Planning & Zoning Board Regular Meeting

September 5, 2023 @ 6:00 pm

Request of Metro Winter Park, LLC: for Conditional Use approval for a two-story, 55-unit multi-family project on the properties at 821 & 831 W. Swoope Ave. and 800, 810 & 830 W. Webster Ave.

Winter Park Commons Swoope & Webster

OVERALL DRAINAGE PLAN

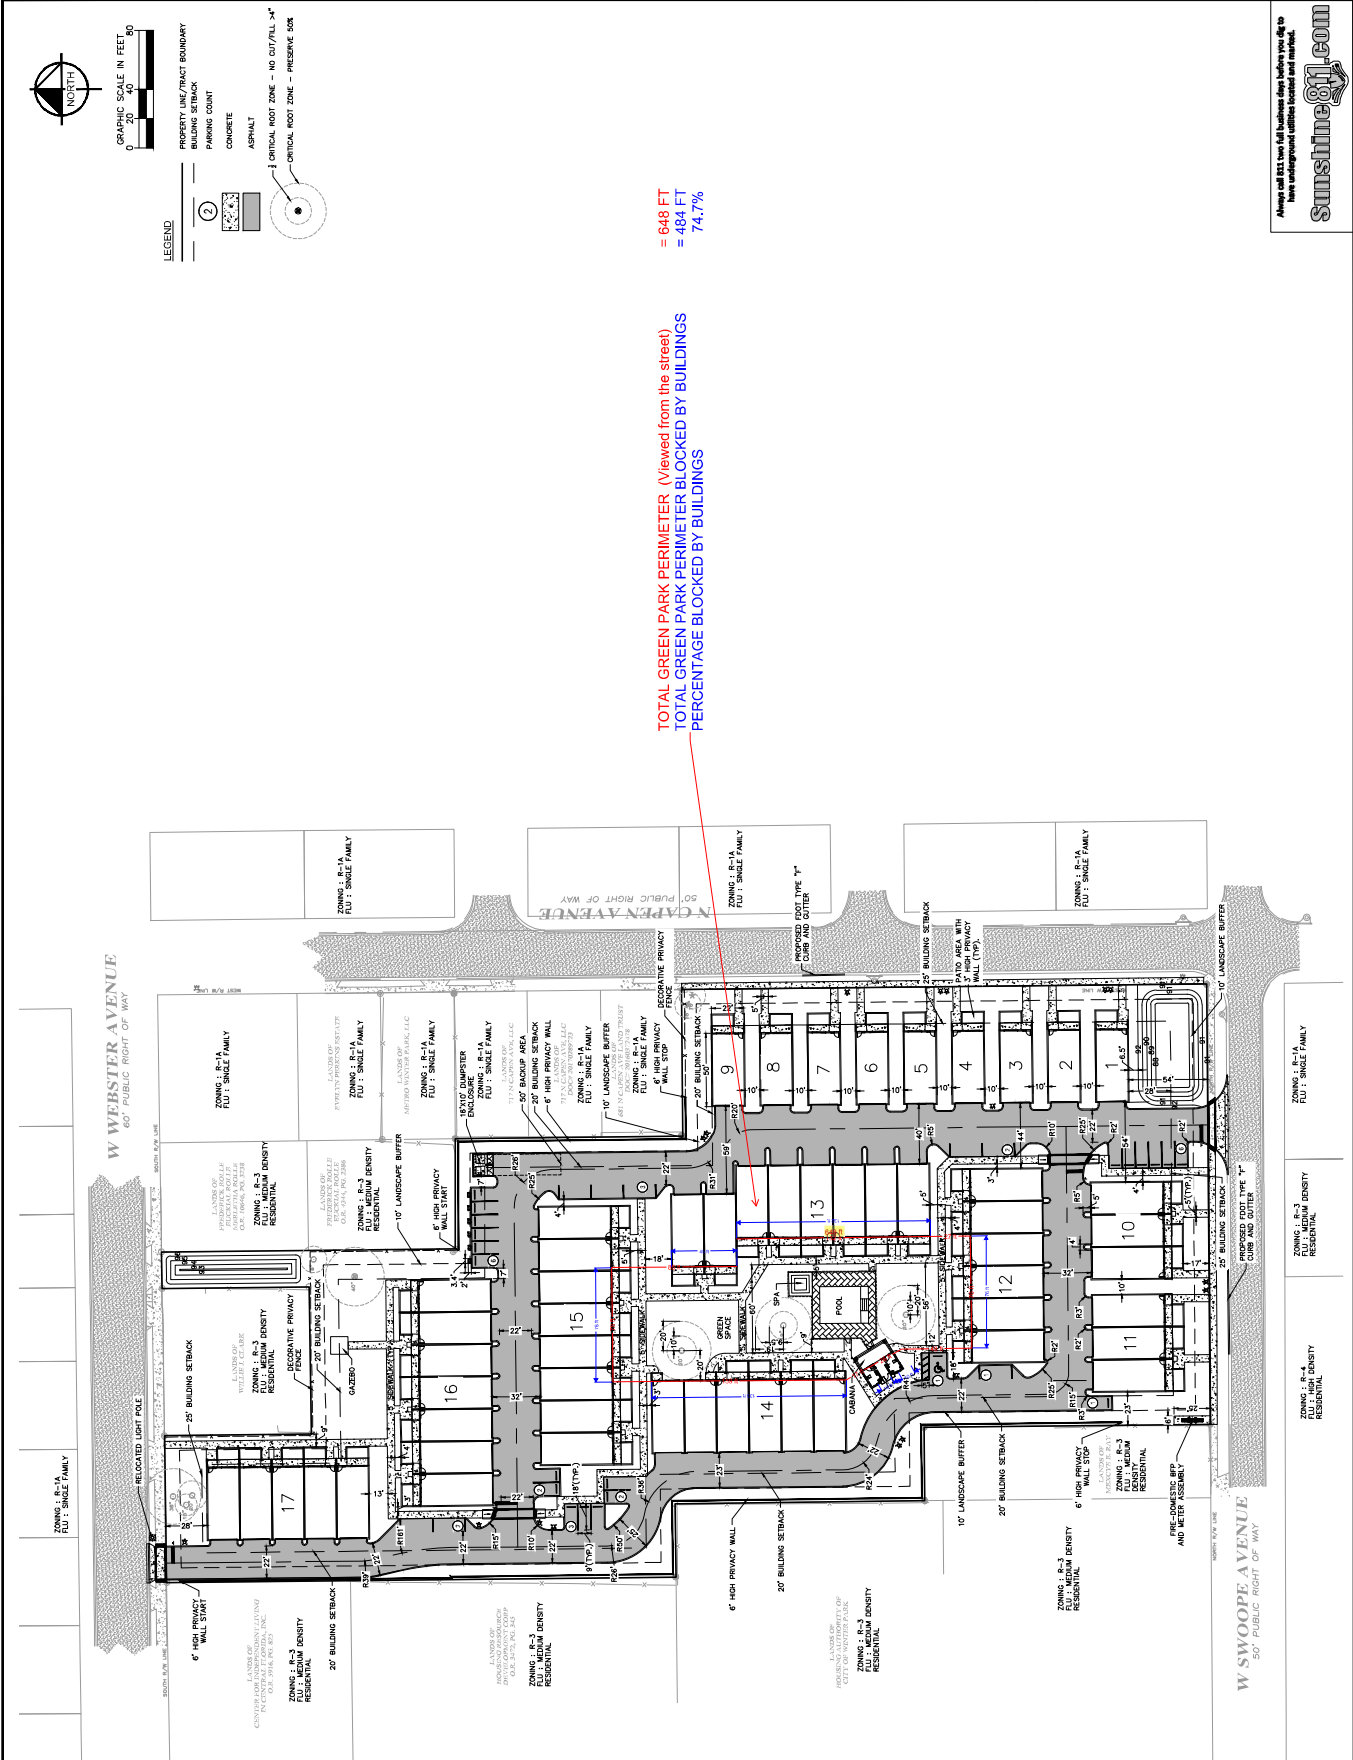
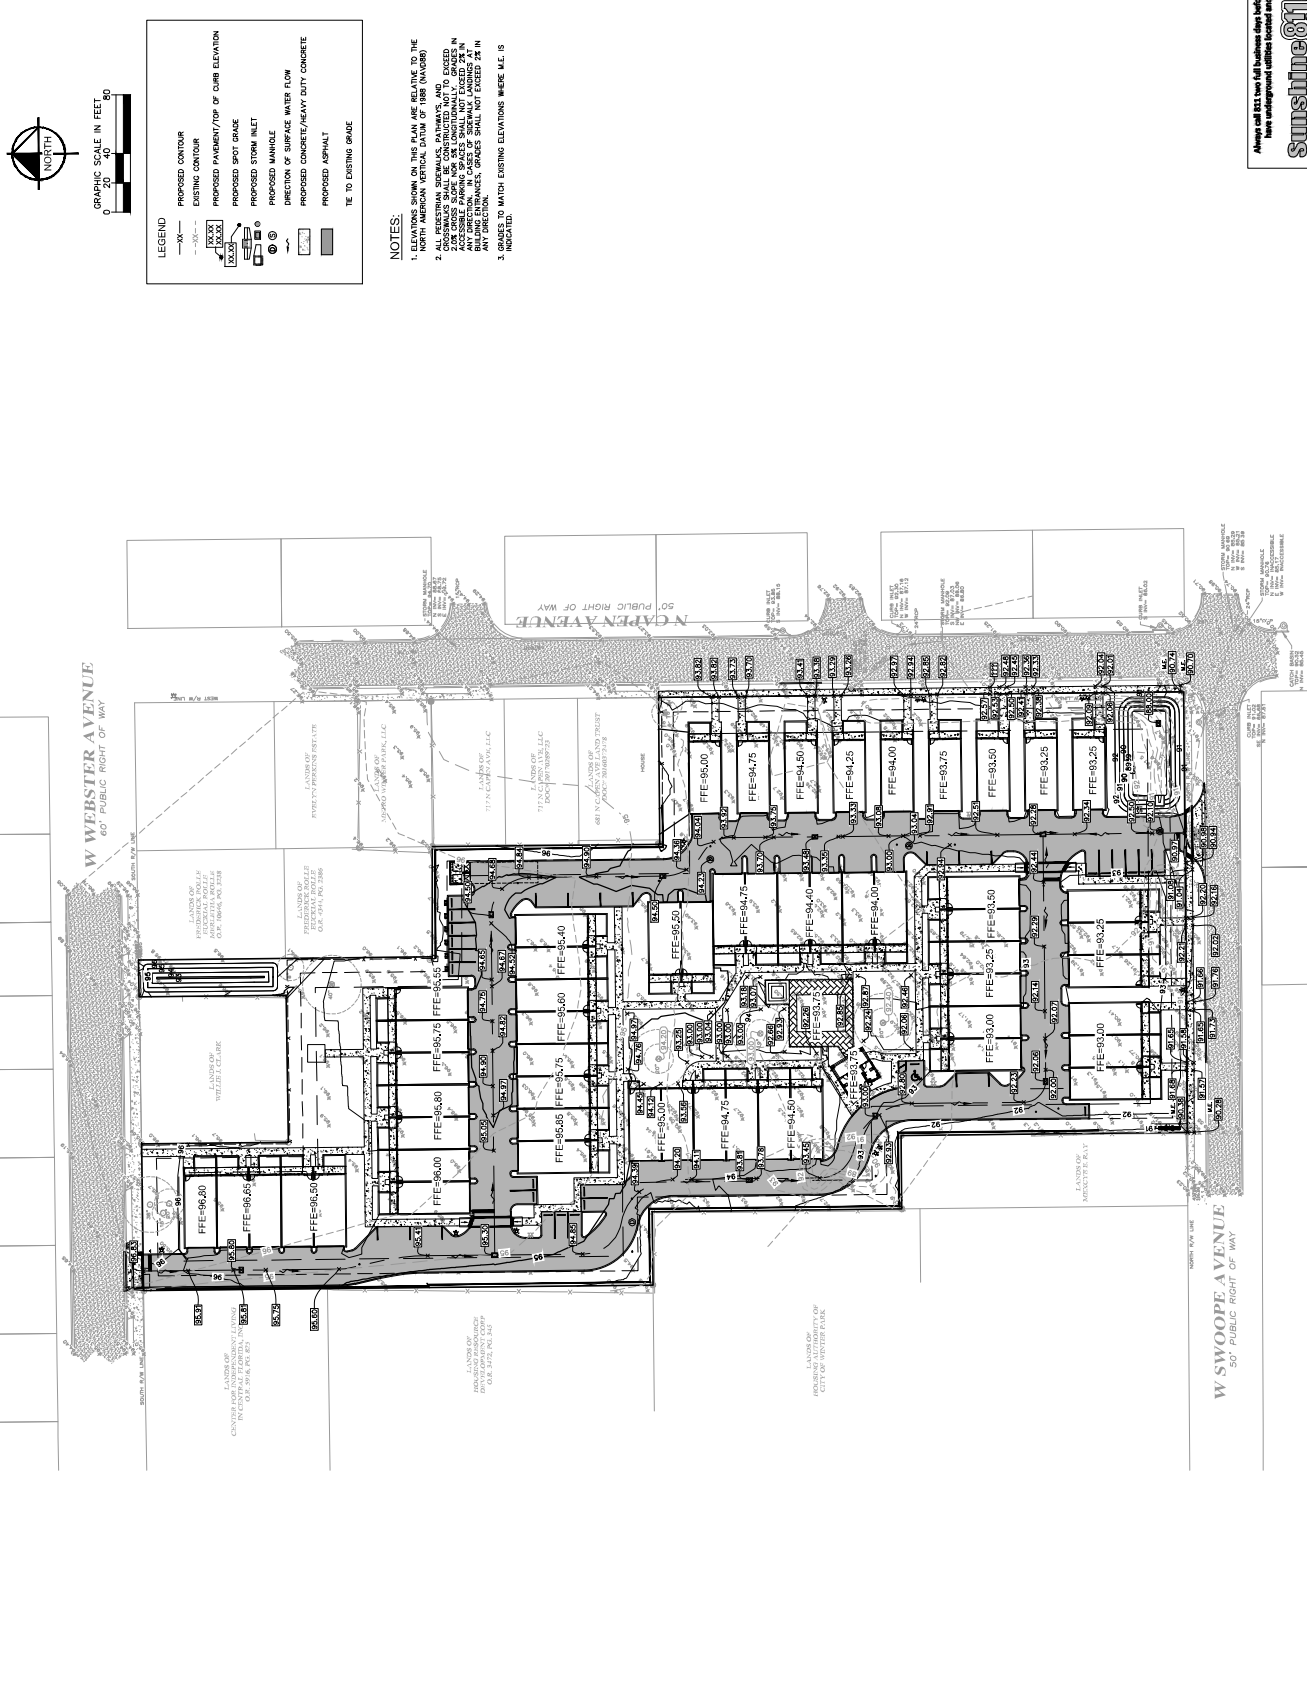
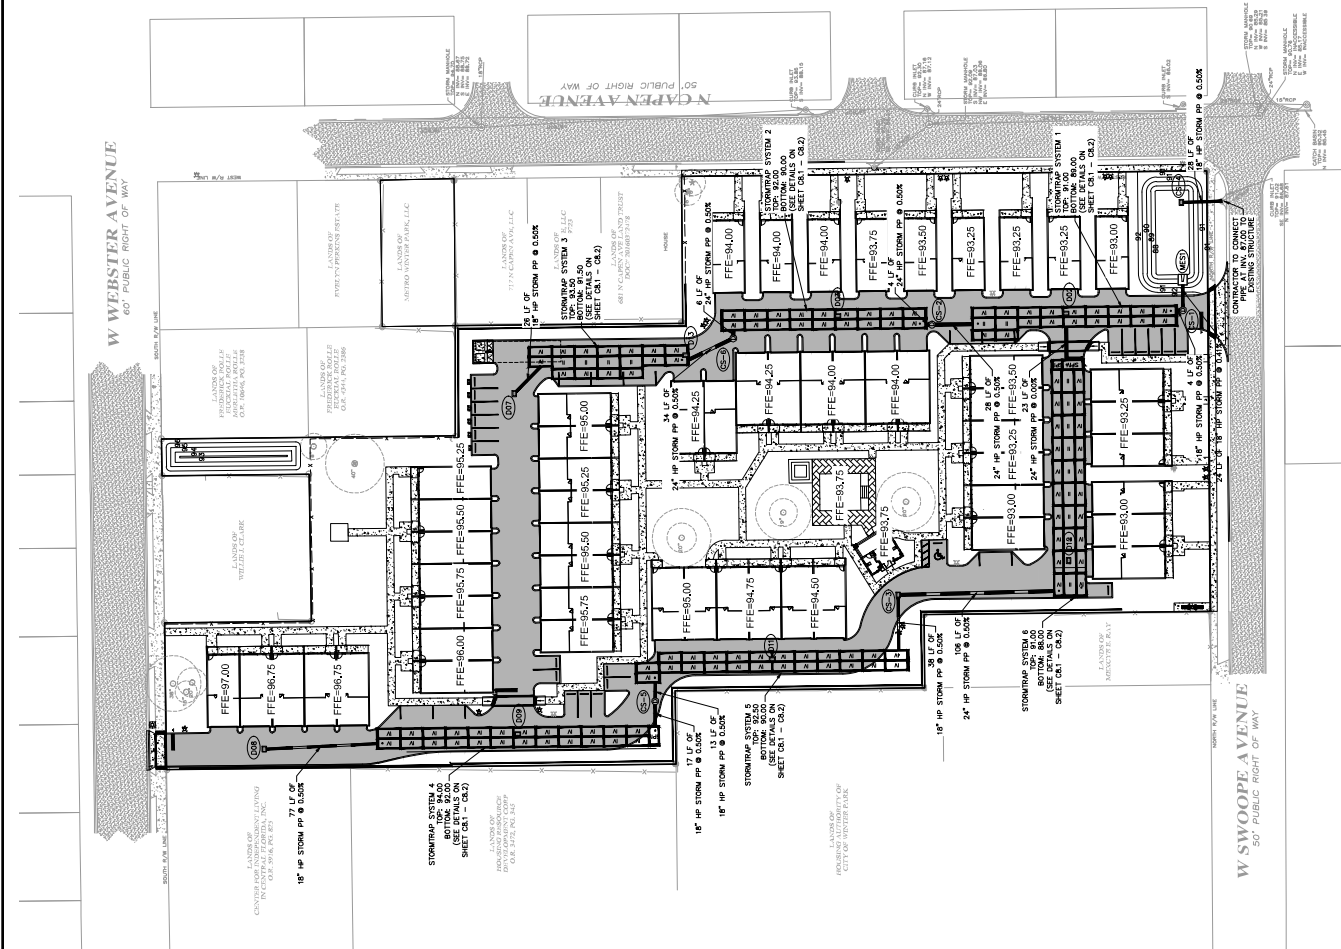
Storm Water Retention: Conditional Use standard #12 states that “the proposed use does not create through....stormwater runoff, any conditions that....negatively impacts ...the

surrounding neighborhood". In order to maximize the density yield for this project, all 3.1 acres of impervious surfaces are proposed to be accommodated for stormwater retention via an underground storm water exfiltration system and one newly added surface swale area. This requires bringing in about two feet of fill over most of the site in order to raise up the exfiltration system above normal ground water elevations. That retention system will now hold 2.2 inches of rainfall (or less depending on how fast it percolates downward). When the City has a major storm event, that seems to happen every 3-5 years, all of the additional storm water above the first 2.2 inches is piped directly off-site and flows to an area of special flood hazard.

Hurricane Ian and the storm that followed two weeks later was a learning experience for the City that revealed challenges to our storm water collection system. For this project there will be an 18-inch pipe that feeds all overflow immediately into the city storm sewer system to travel on down Capen Avenue to Denning Drive/MLK Jr. Park and the adjacent neighborhood. The flooding which has closed Capen Avenue, Denning Drive and Morse Blvd. and overflowed and flooded nearby homes and is one of the most challenging situations that exists in the City. The City cannot direct more storm water from a new 3.1 acres of impervious surfaces down to increase the flooding to those homes.

Presently, this 4.51-acre Patmos Chapel property is not generating any off-site storm water overflow. First, the site has only about 20% impervious coverage. Second, the driveways are crowned to keep stormwater on-site and the swales around the Church have no control structures that pop-off overflow, because the system was built in 1978. As a result, all of new out-flow beyond the 2.2 inches proposed will be new flow headed to the flood hazard area. Adding more flow from 3.1-acres of runoff will work to negate the storm water design improvements currently under study for that Capen/Denning/Morse/MLK Jr. Park area.

What has changed since the September meeting is that the applicant's added some small swale retention areas that increased the capacity by 0.2 inches. Two-tenths of an inch is insignificant. The Public Works Department continues to 'strongly recommend' that this project proceed based upon an above ground storm water retention system or to accommodate more runoff on-site before discharge. The applicant could propose a significant increase in the extent of the underground exfiltration capacity to hold something such as a meaningful 3 inches stormwater but that will cost additional money that the applicant is unwilling to spend.
